III. HEATUP AND COOLDOWN CURVES AND SURVEILLANCE CAPSULE SCHEDULE REVISION

Proposed Change

Replace Table 3.4-4 and Figures 3.4-1, 3.4-2, and 3.4-3 with the appropriate revised Table and Figures.

ATTACHMENT C: NUREG 0737 REQUIRED TECHNICAL SPECIFICATIONS

FIGURE 3.4-2

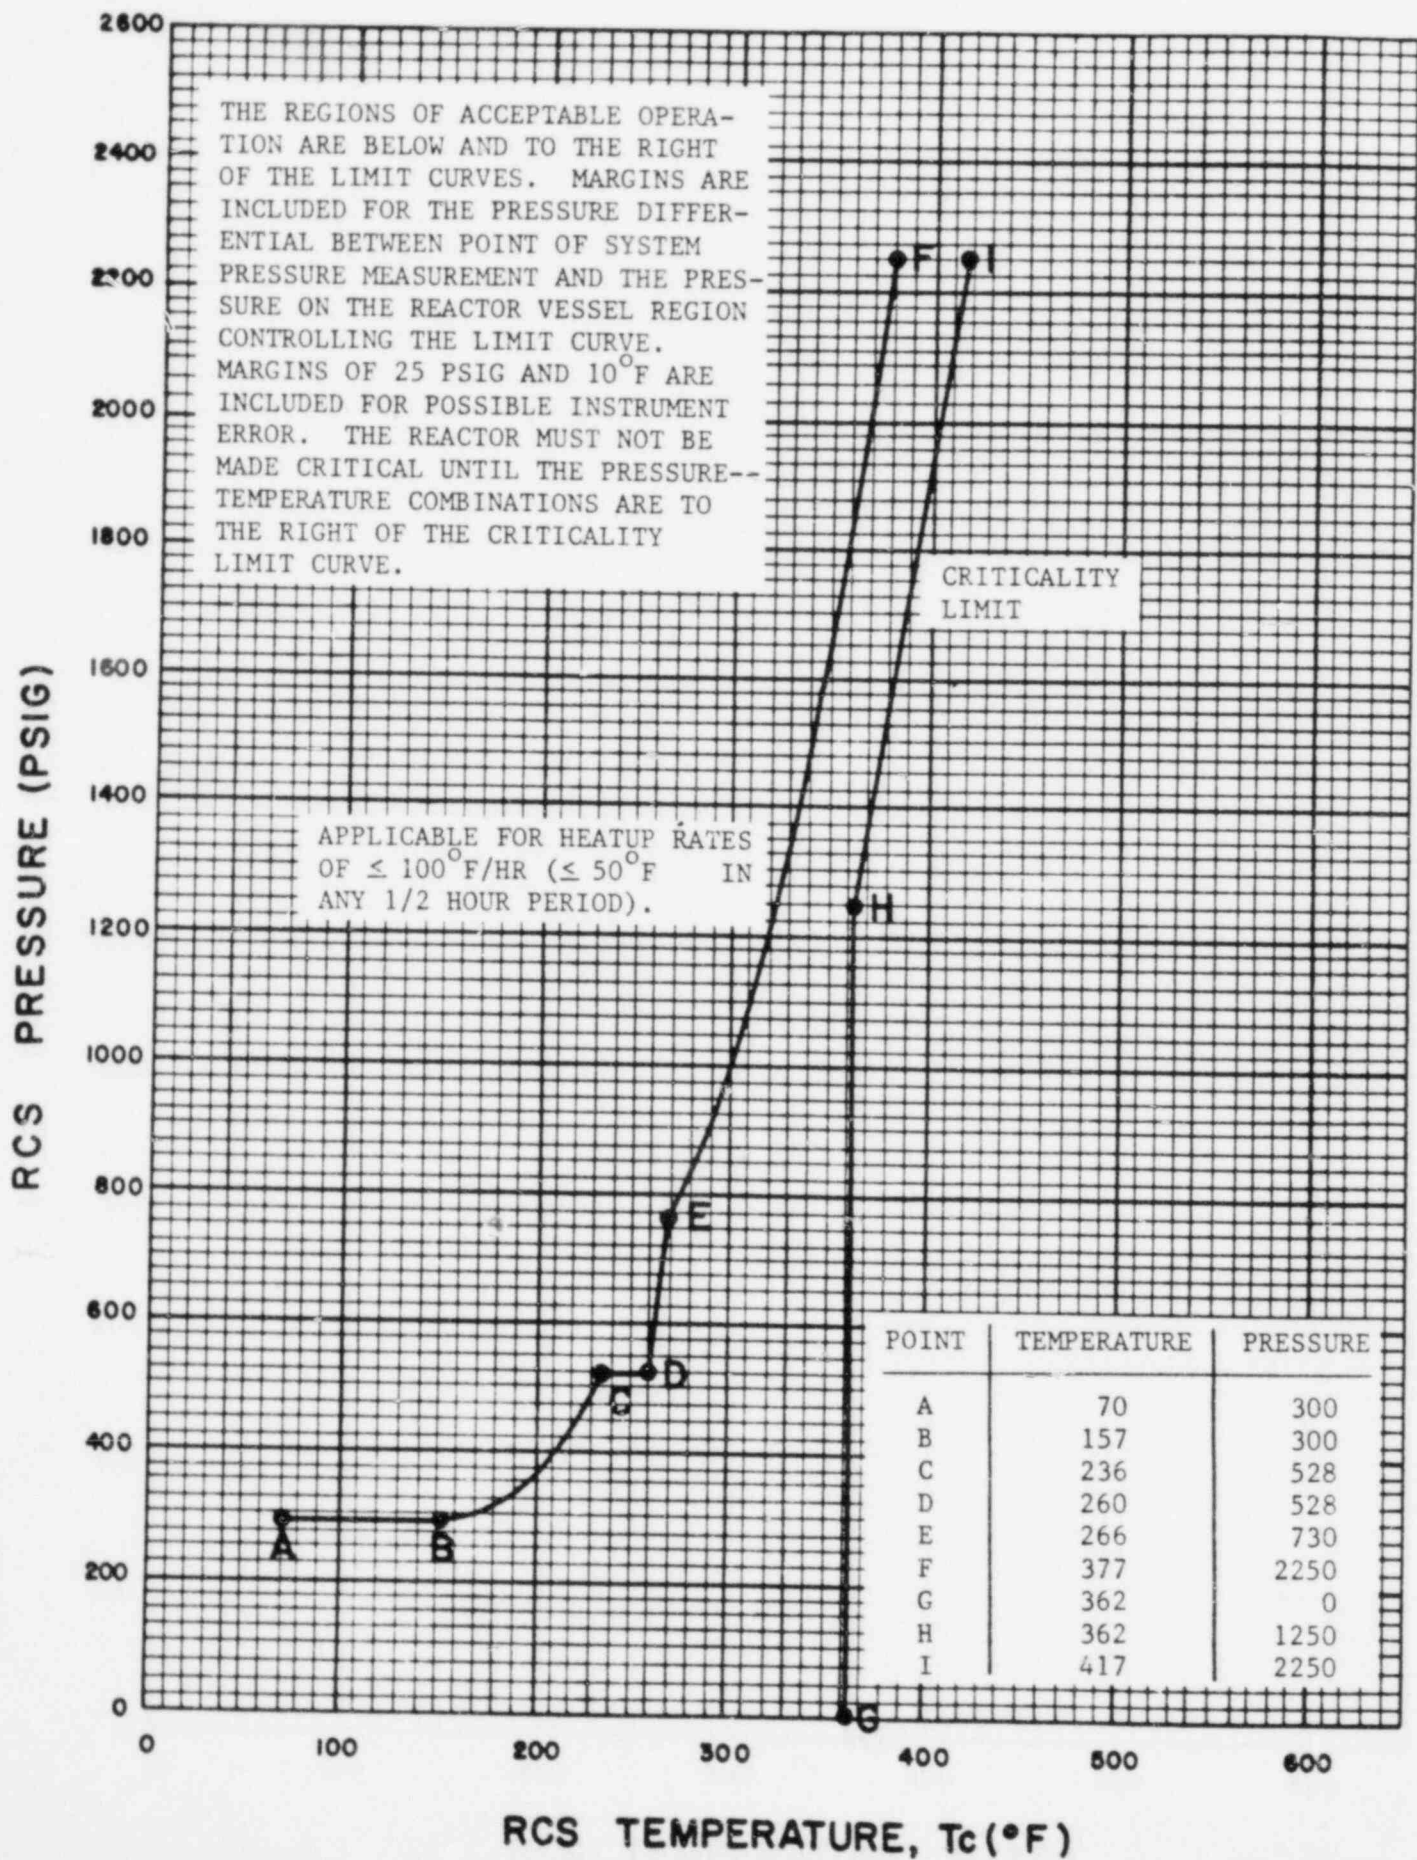
The proposed changes are submitted as a result of the irradiated reactor vessel surveillance as required by Technical Specification 4.4.9.1.2.

The new pressure temperature limits of the reactor coolant pressure boundary were established in accordance with the requirements of 10 CFR 50, Appendix G. The methods and criteria employed that establish operating pressure and temperature limits are described in topical report BAW-10046. The revised

Figure 3.4-2 presents the pressure-temperature limit curve for normal heatup. This figure also presents the core criticality limits as required by Appendix G to 10 CFR50. Figure 3.4-3 presents the pressure temperature limit curve for normal cooldown. Figure 3.4-4 presents the pressure-temperature limit curves for heatup and cooldown for inservice leak and hydrostatic testing. These figures are discussed in greater detail in BAW-1679, Rev. 1, June 1982, Analysis of Capsule CR3-B from Florida Power Corporation, Crystal River Unit 3 Reactor Vessel Materials, Surveillance Program.
